TO ALL BIDDERS: Renovations of the Library on the Kemper Campus
Boonslick Regional Library – Cooper County Branch

Item No. MEP1 – CHANGE – RE-ISSUE ALL PLUMBING SHEETS

1 MAIN LEVEL PLUMBING RENOVATION PLAN
SCALE: 1/4"=1'-0"

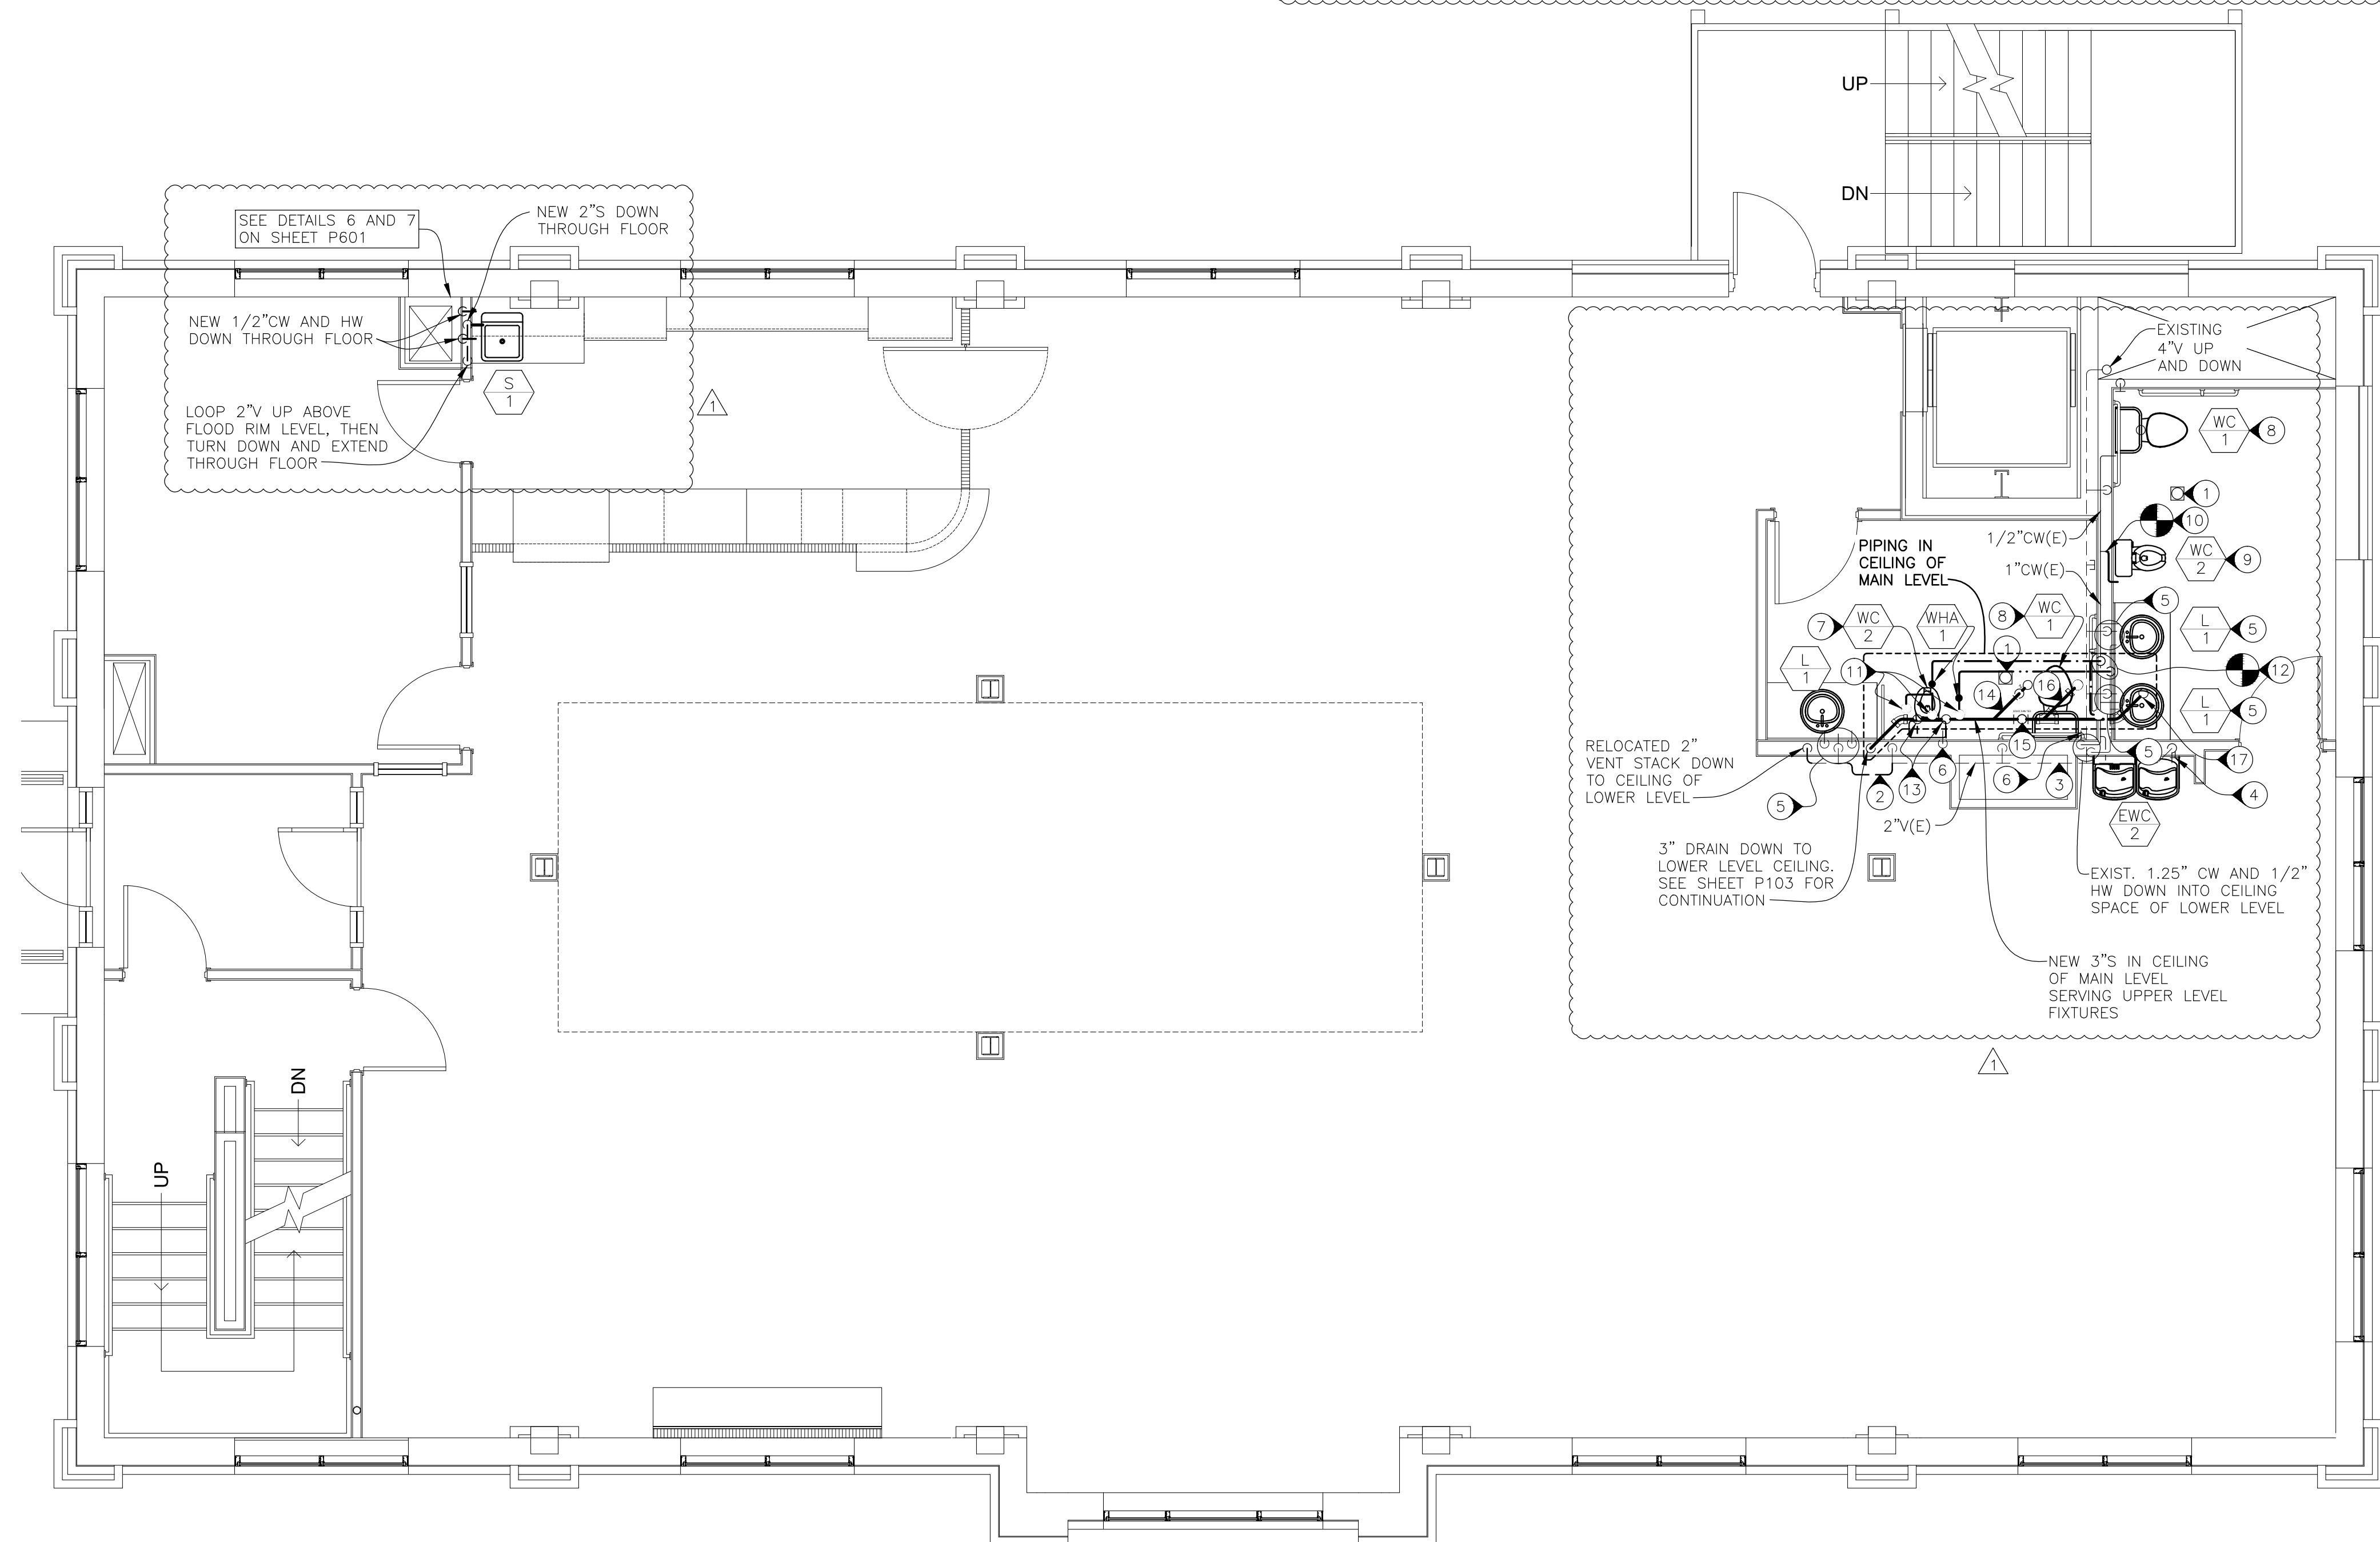
- 1) Additional notes have been added and / or modified.

Scale: 1/4" = 1'-0"
UPPER LEVEL PLUMBING RENOVATION PLAN

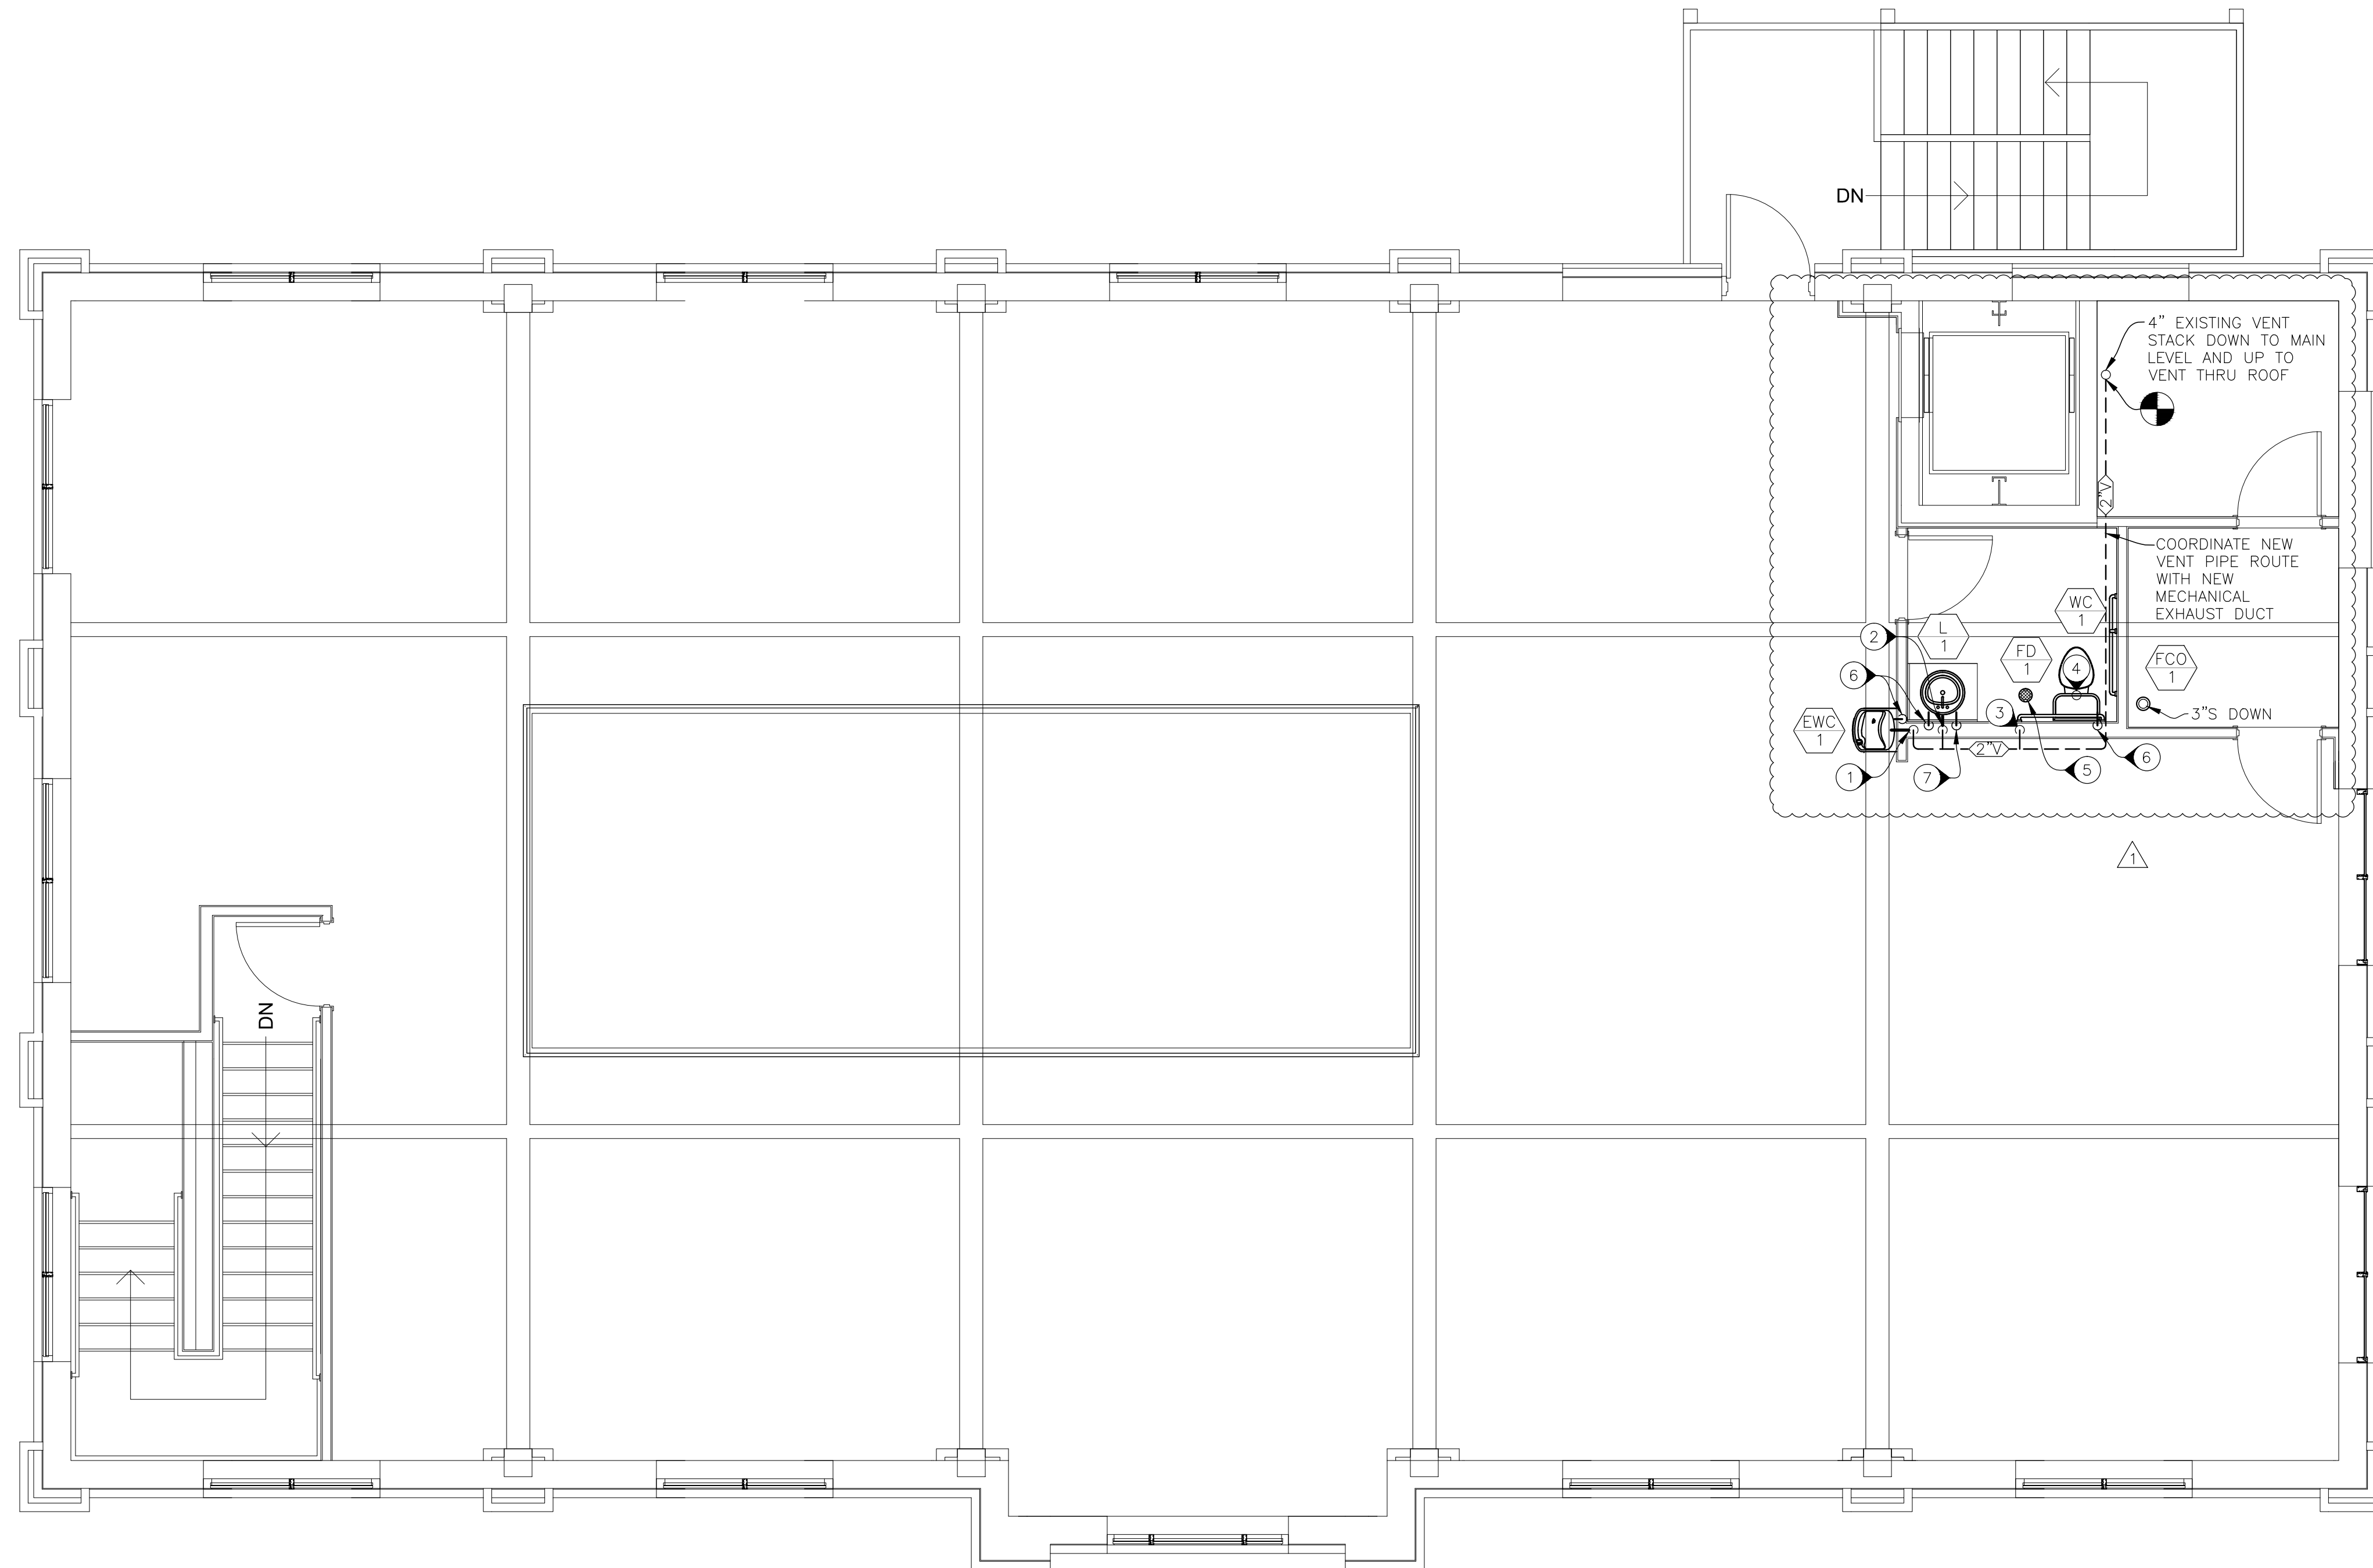
- 1) Additional notes have been added and / or modified.
